Subject: MHI's Responses to US-APWR DCD RAI No.649-5123 Revision 2 (SRP 19.0)

Responses to Request for Additional Information No.649-5123
Revision 2

US-APWR Design Certification

RAI NO.: NO. 649-5123 REVISION 2
SRP SECTION: 19 – Probabilistic Risk Assessment and Severe Accident Evaluation
APPLICATION SECTION: 19.1.5.3
DATE OF RAI ISSUE: 10/13/2010

Figure 2 Human Error Probability assignment sub-tree for MCR Event Tree

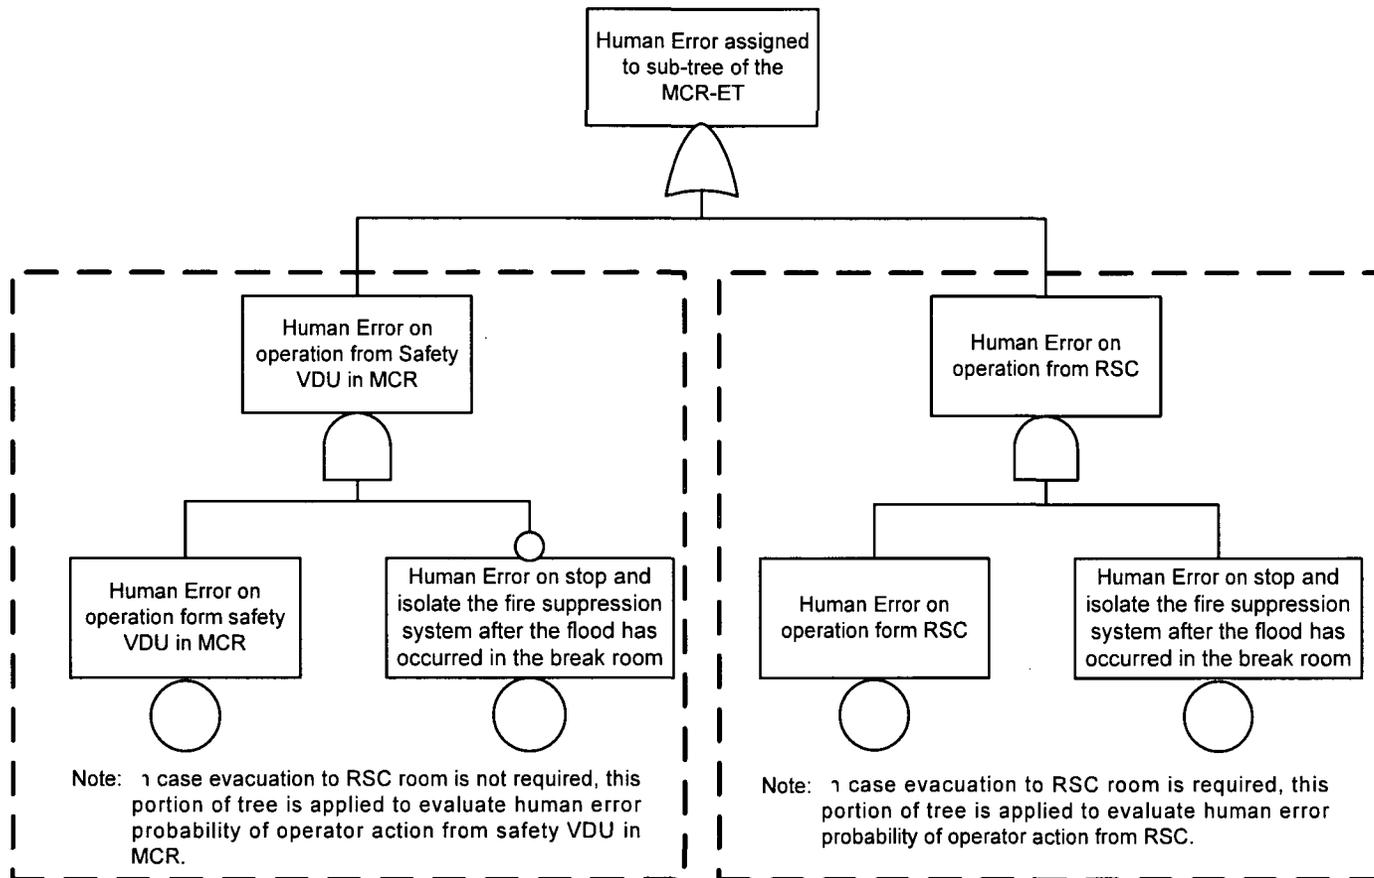
(2) Impact of the modeling for flooding propagation to the MCR

A flooding propagation to the MCR is not considered in the base case because the MCR is protected from flooding as described in the answer to Question 19-486.

This sensitivity study is selected to determine the impact of modeling in the case of flooding propagation to the MCR. In this case, the operator actions in the MCR or the RSC are assumed as that for the fire event in the MCR. The modeling of this sensitivity study case is as follows:

The flooding scenario in the MCR is evaluated using the MCR event tree which has been developed for the MCR fire risk assessment. The MCR event tree is shown in Figure 1. The operator action from the remote shutdown console (RSC) has been considered in the fault trees as shown in Figure 2.

The CDF resulting from this sensitivity study scenario is $2.4E-12/RY$ ($1.4E-5$ (frequency) \times $1.7E-7$ (CCDP) = $2.4E-12$ (/RY)). The LRF is $5.3E-13/RY$. This result shows that an adequate operator action in the MCR and RSC is effective in reducing the internal flooding risk even though the MCR is not protected from flooding.

A flooding propagation to the MCR is not considered in the base case. A sensitivity study was performed to identify the effectiveness of mitigation actions in the MCR and the RSC in the case of flood propagation to the MCR. The CDF and LRF resulting from this sensitivity study scenario are $2.4E-12$ /RY and $5.3E-13$ /RY, respectively. This result shows that an adequate operator action in the MCR and RSC is effective in reducing the internal flooding risk even though the MCR is not protected from flooding.
